Access Compliance Report

(Curb Ramps)

Intersection ID: 45494	Main Street: BUGGY_HORSE_RD	Cross Street: COTTON_STAND_RD	Location: NE
ADA ID: 91D3632AB87B	Ramp Type: PerpDiag	Initial Pass/Fail: Fail	Overall Compliance: No
Severity Score: 13.75			
Codes/Mitigation Info/Possible Solution		Field Measurements/Component Compliance

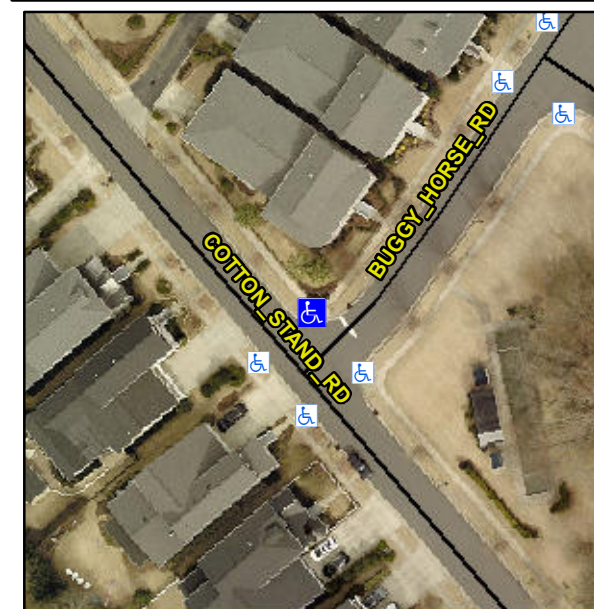
Not Found, R304.2.2, R304.5.3

Compliance	Description	Data	Compliance	Description	Data
N/A	Ramp Length (in)	77.0	No	Ramp Slope (%)	11.8
Yes	Ramp Width (in)	48.0	No	Ramp XSlope (%)	2.1
N/A	Flare Type LT	N/A	N/A	Flare Type RT	N/A
N/A	Flare Slope LT (%)	N/A	N/A	Flare Slope RT (%)	N/A
N/A	Flare Traversable LT?	N/A	N/A	Flare Traversable RT?	N/A
N/A	Landing Length (in)	N/A	N/A	DWS Provided?	N/A
N/A	Landing Width (in)	N/A	N/A	DWS Contrast?	N/A
N/A	Landing Slope (%)	N/A	N/A	DWS Length (in)	N/A
N/A	Landing X Slope (%)	N/A	N/A	DWS Full Width?	N/A
N/A	Landing Curb? (Y/N)	N/A	N/A	DWS Offset (in)	N/A
N/A	Shared Landing?	N/A			
N/A	Gutter Ponding?	N/A	N/A	Gutter Slope (%)	N/A
N/A	Gutter Lip Ht (in)	N/A	N/A	Gutter X Slope (%)	N/A
N/A	Painted X Walk1?	No	N/A	Painted X Walk2?	No
	X Walk 1 Direction	To SW		X Walk 2 Direction	To SE
N/A	X Walk 1 Width (in)	N/A	N/A	X Walk 2 Width (in)	N/A
	X Walk 1 Slope (%)	3.4		X Walk 2 Slope (%)	0.4
	X Walk 1 X Slope (%)	2.3		X Walk 2 X Slope (%)	2.7

Remove & Replace Curb Ramp With Two New Directional Ramps or Equivalent.
